**ADDENDUM
NO. 2**

**LAKE PRAIRIE ELEMENTARY SCHOOL - CLASSROOM ADDITION
Lowell, IN 46356**

DATE: July 10, 2023
PROJECT: Addition to Lake Prairie Elementary School
OWNER: Tri-Creek Community Schools
PROJECT NO.: 2022071.00

Client Project No:	VPS Project No:
		2022071.00
	Project Issue Date:	JUNE 2023
	Drawing No:	P-101

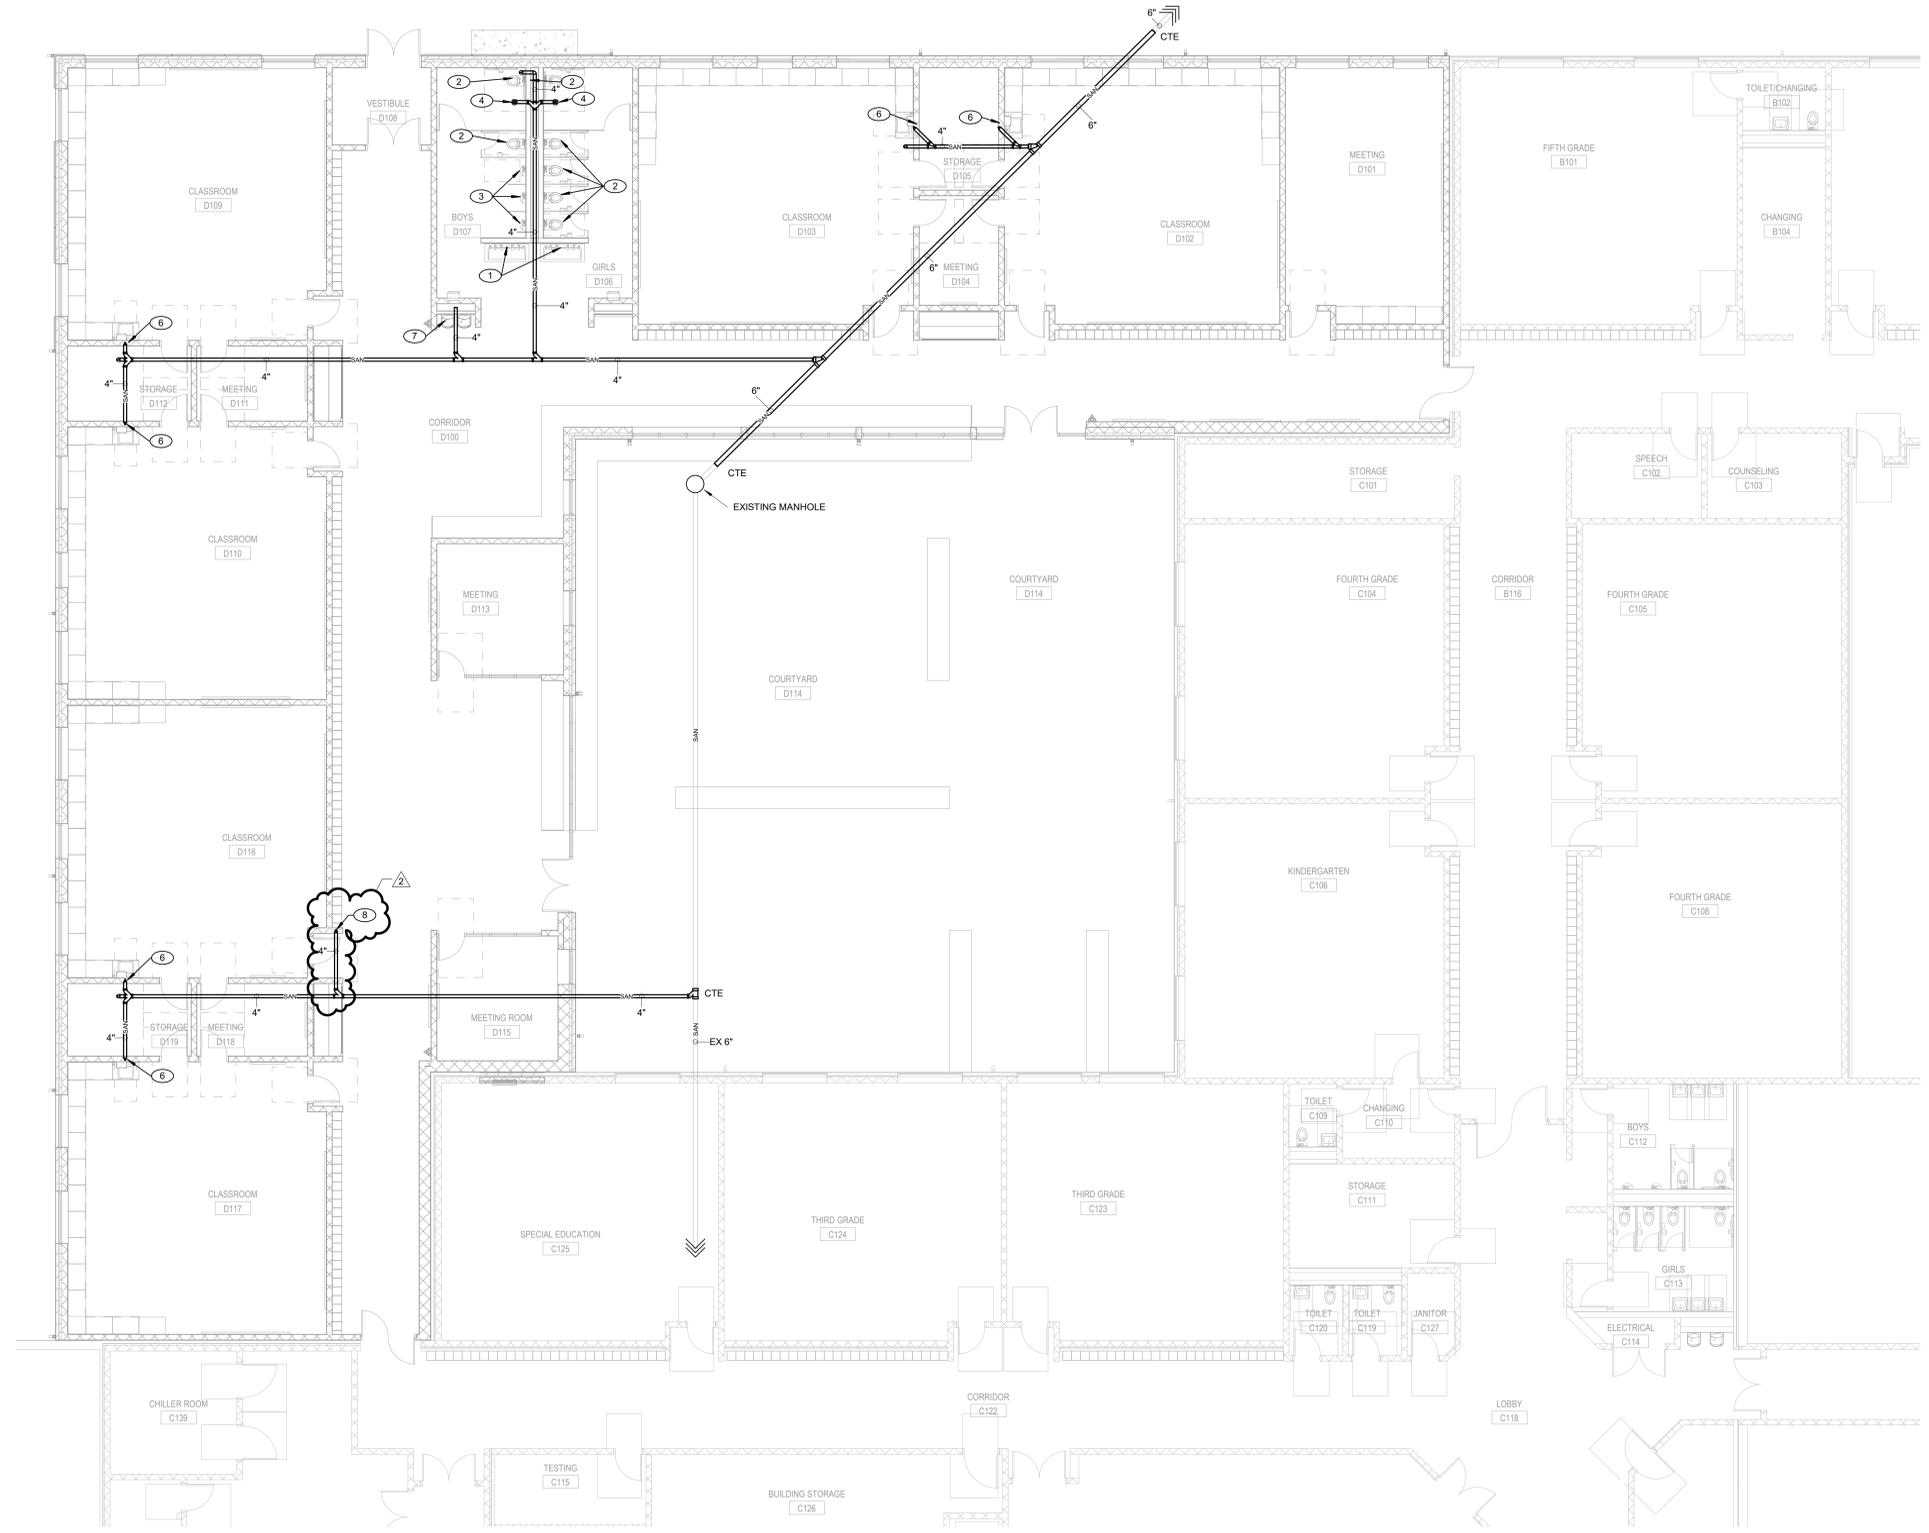
- 2-21 P-101: Replace drawing in its entirety with attached revision (added 4" sanitary pipe to 2" rise for DOAS-1 condensate).
- 2-22 P-102: Replace drawing in its entirety with attached revision (added 2" sanitary for DOAS-1 condensate).

Client Project No:	VPS Project No:
		2022071.00
	Project Issue Date:	JUNE 2023
	Drawing No:	M-102

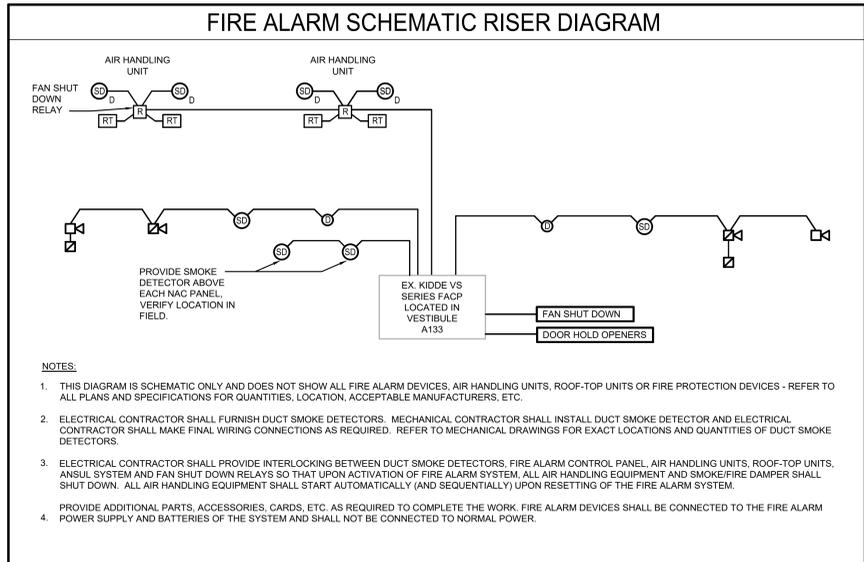
- 2-23 M-102: Replace drawing in its entirety with attached revision (added condensate piping for DOAS-1).
- 2-24 E-200: Replace drawing in its entirety with attached revision (revised Electrical Schematic One-Line Riser Diagram requirements).
